ADDENDUM NO. 1 TO PROJECT NO. 47268

CONSTRUCTION AND ELECTRICAL WORK
PROVIDE CONGREGATE RECREATION PENS
S-BLOCK, BUILDING 45
GREENE CORRECTIONAL FACILITY
165 PLANK ROAD
COXSACKIE, NY

December 3, 2024

DRAWING NUMBER: E-703

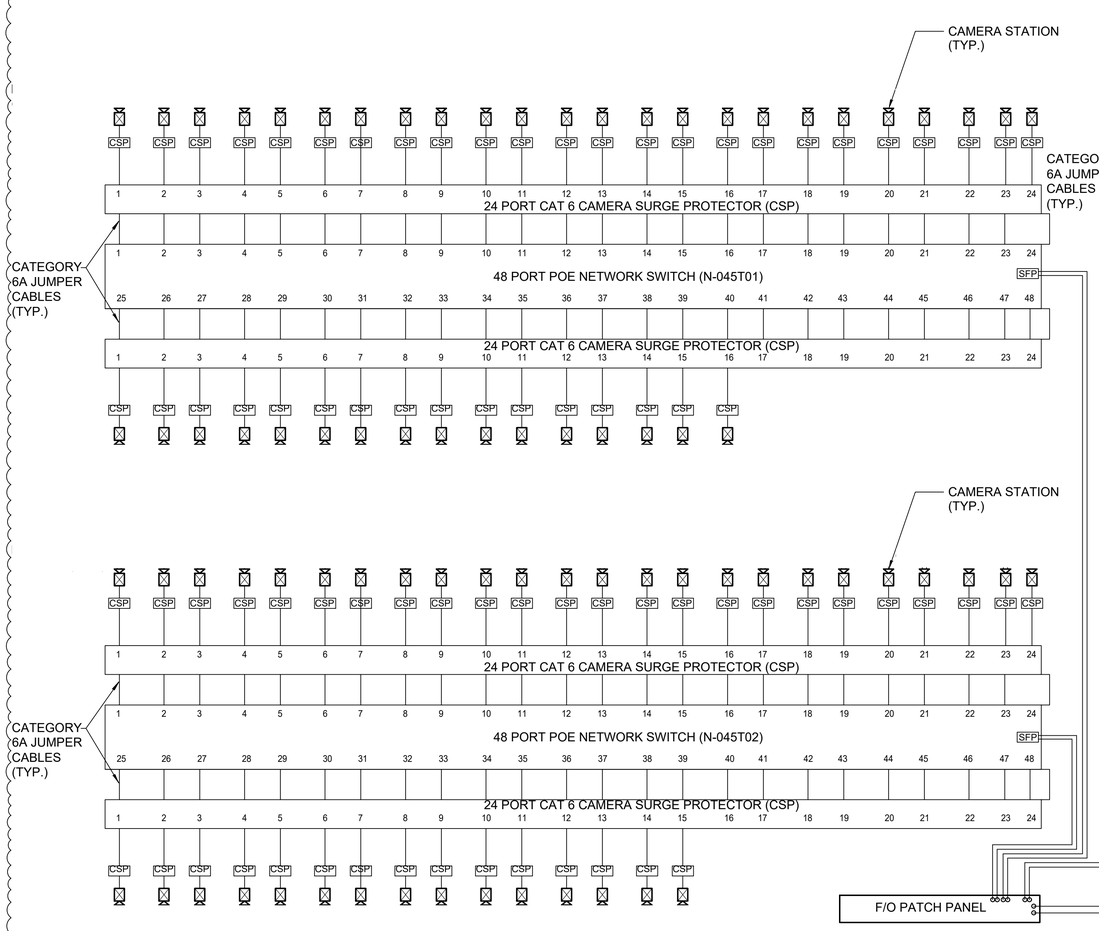
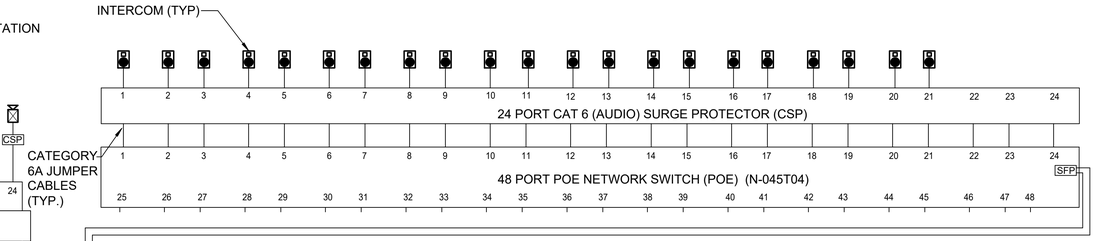
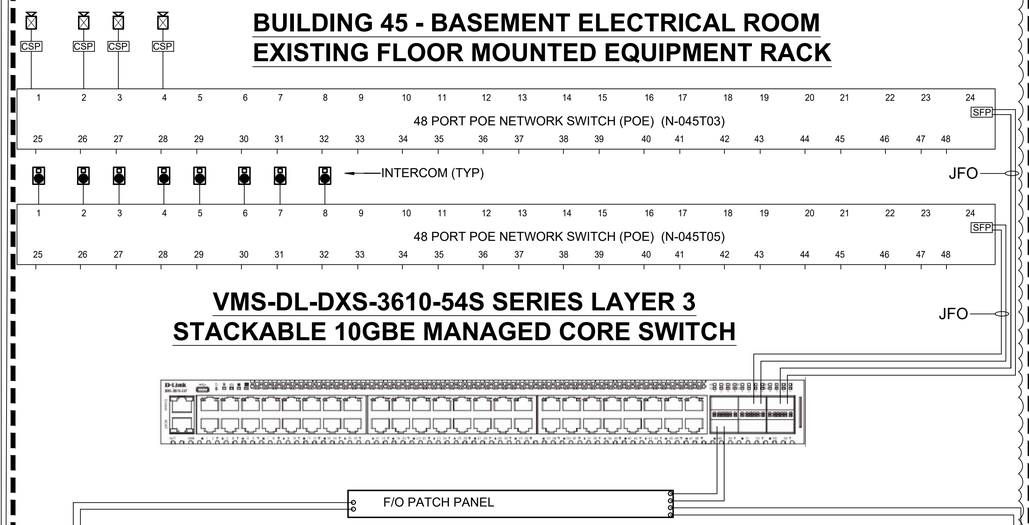
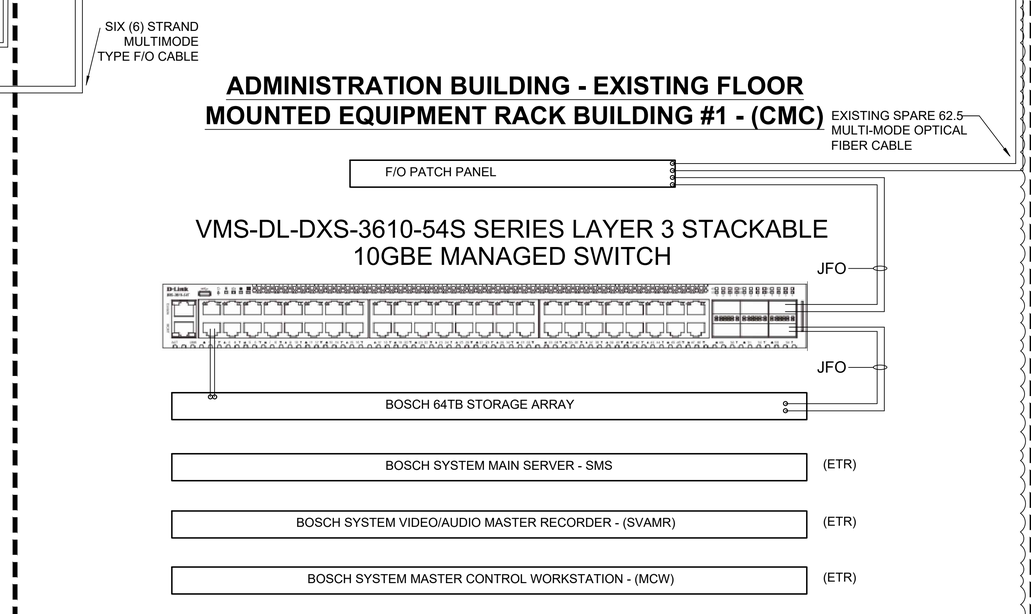
4. Revised Drawings:
   a. Drawing Nos. E-703, E-704 and E-707 noted "Addendum 1 11/21/24" accompany this Addendum and supersede the same numbered originally issued drawings.
